### V-W Pinion Modification for Webster Conversion

WEBSTER RACING INC.,  
 244 Shoreline Hwy.,  
 Mill Valley, Calif., 94941

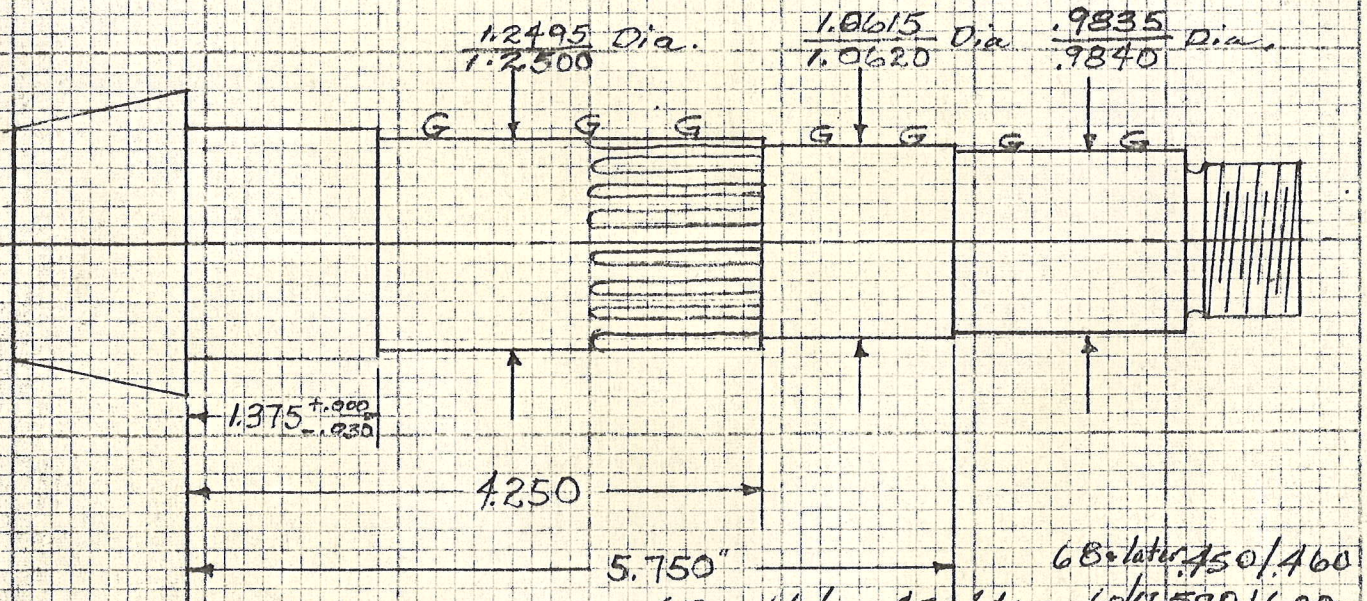
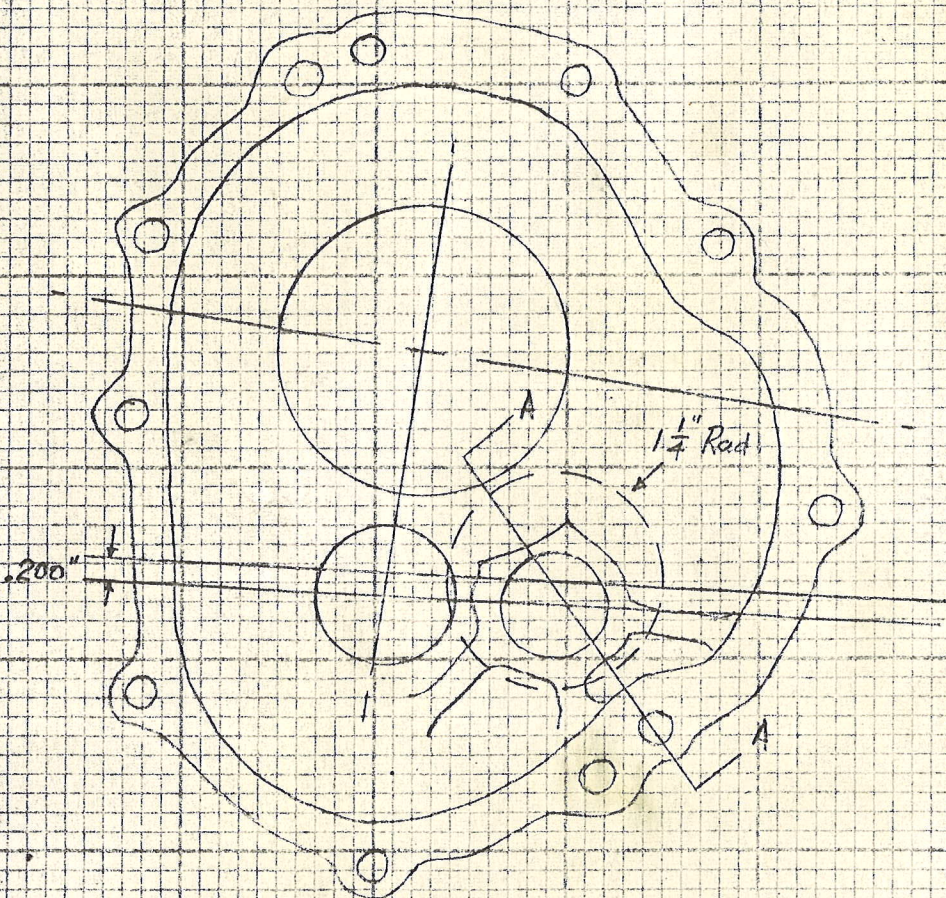
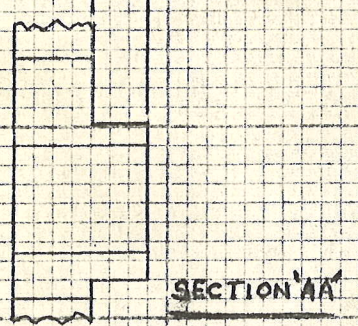
**MAIN CASE MODIFICATION**  
 Machine face of reverse boss on  $\frac{1}{4}$ " rad. to .605"/.620" from main pinion abutment face.
